Scientific Analysis
Administrative Change Notice

1. Document Number:	ANL-NBS-HS-000034	2. Revision:	02	3. ACN:	01
4. Title:	Water-Level Data Analysis for the Saturated Zone Site-Scale Flow and Transport Model				
5. No. of Pages Attached:	1

Figure 1-2. Location of Boreholes Used to Characterize the Potentiometric Surface in the Yucca Mountain Area

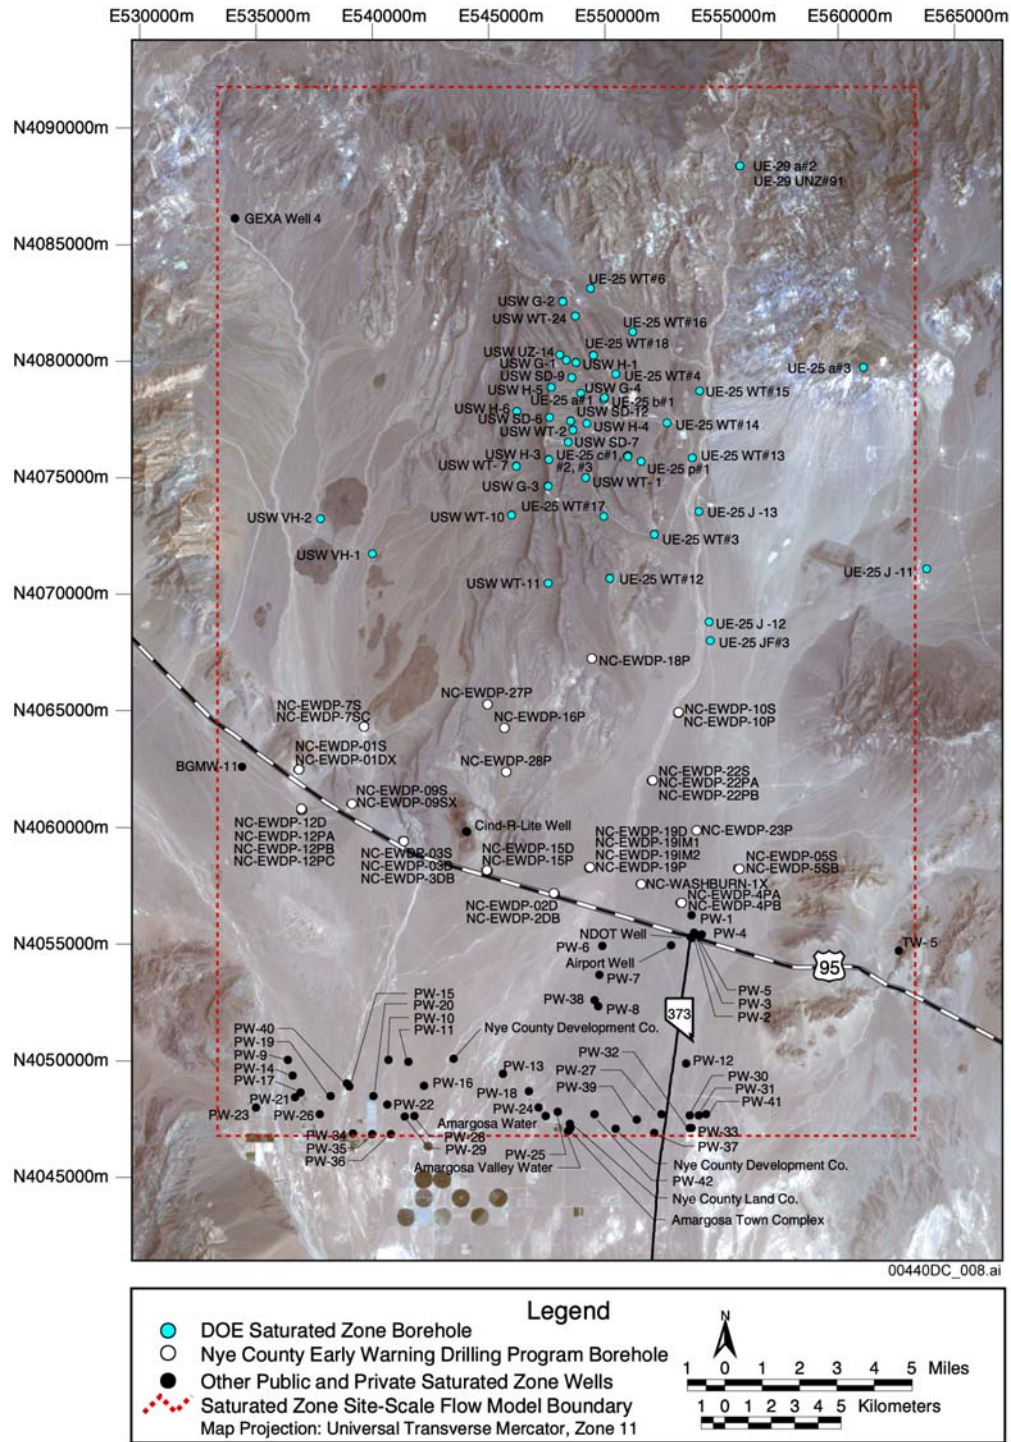
6. Approvals:		
Preparer:	G.H. Nieder-Westermann Print Name and Sign <i>G.H. Nieder-Westermann</i>	02/10/2005 Date
Checker:	Ken Rehfeldt Print name and sign <i>Ken Rehfeldt</i>	02/10/2005 Date
QER:	Judy Gebhart Print name and sign <i>JG Gebhart</i>	2/10/05 Date
Responsible Manager:	Ming Zhu Print name and sign <i>Ming Zhu</i>	2/10/05 Date
7. Affected Pages	8. Description of Change:	
1-3	Corrected typographical error <i>GW 2/10/05</i> DTN citation in Figure 1-2 incorrectly identified as: 0307GSC03094.000 [DIRS 170556]. The correct DTN citation is: <i>M0307GSC03094.000</i> [DIRS 170556]. This error was identified in CR 4161.

Sources: GS010608312331.001 (Output of this analysis), DTN: MO0103COV01031.000 [DIRS 155271], DTN: MO0107COV01057.000 [DIRS 157194], DTN: MO0203GSC02034.000 [DIRS 168375], DTN: MO0206GSC02074.000 [DIRS 168378], DTN: MO0307GSC03094.000 [DIRS 170556].
